SIL 6-WT-17
 September, 2017
 Page 1 of 4

SUBJECT: Release of Remanufactured WTEC II Electronic Control Unit (ECU)

MODELS AFFECTED: 3000 and 4000 Series Product Family Transmissions

Figure 2. ECU Cover

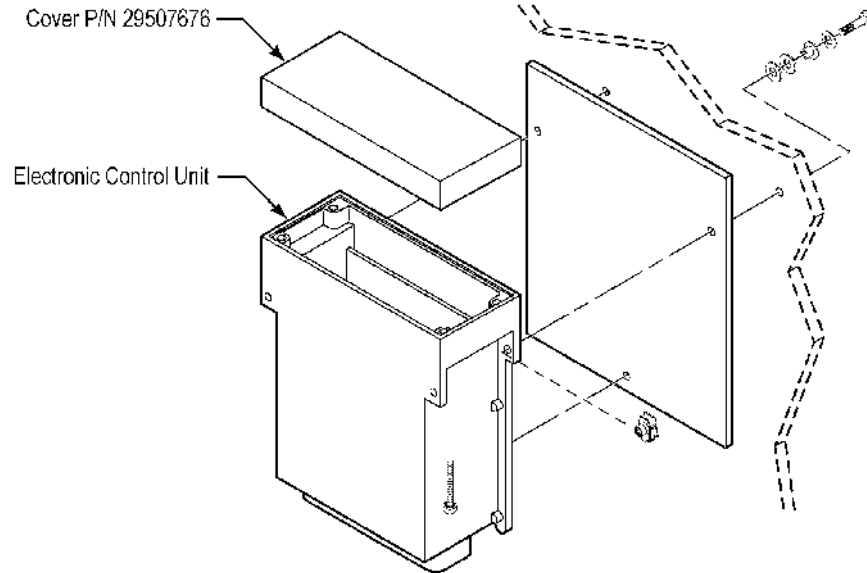
1. Separate the shift selector from the ECU by removing the four (4) slotted Torx® head screws.
2. Carefully disconnect the shift selector ribbon cable at the connector on the ECU circuit board.
3. Remove the four (4) slotted Torx® head screws holding the cover P/N 29507676 to the top of the replacement ECU. Refer to Figure 2.

As outlined in TPPL 16-TPPL-09, there is a core fee associated with the purchase of P/N R29517003. The Remanufactured ECU is shipped in the remote configuration with metallic cover P/N 29507676. When P/N R29517003 is used to replace the ECU in an integral Shifter/ECU installation, remove cover P/N 29507676 and install it on the ECU core before shipment to the remanufacturing center location identified in the TPPL. ECU Cores returned without cover P/N 29507676 will be assessed a core deduction.
